**Section 38 Agreement Works,
Land South of Rowley Lane,
Fenay Bridge, Huddersfield**

Stage I Road Safety Audit

April 2025

Location: Footways on Road 1 and Road 2 at transition from conventional street with footways on both sides to shared surface treatment

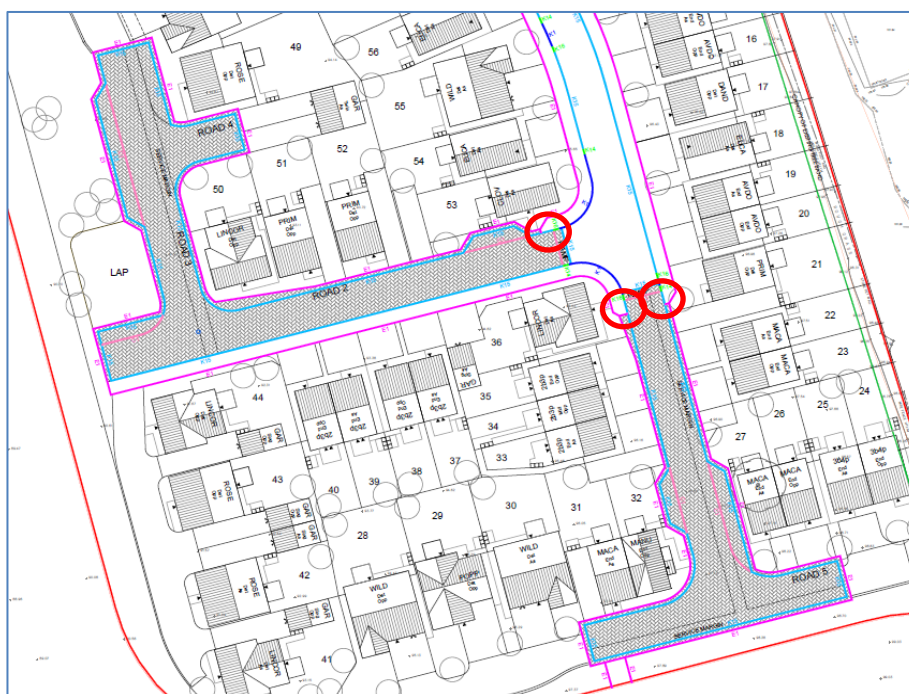
Summary: Risk of pedestrian trip/fall injuries due to lack of suitable connection between footway and carriageway

At the transition from conventional street with footways on both sides to shared surface treatment, it is assumed that the intention is for pedestrians to continue their journeys on carriageway. However, there appears to be a 30mm bull nosed kerb proposed at the footway/shared surface interface. A kerb with even a reasonably small upstand could increase the risk of pedestrian/trip fall injuries and may physically prevent those in wheelchairs/mobility scooters from accessing the shared surface area.

It is recommended that a suitable flush transition between conventional footway and shared surface areas is provided.
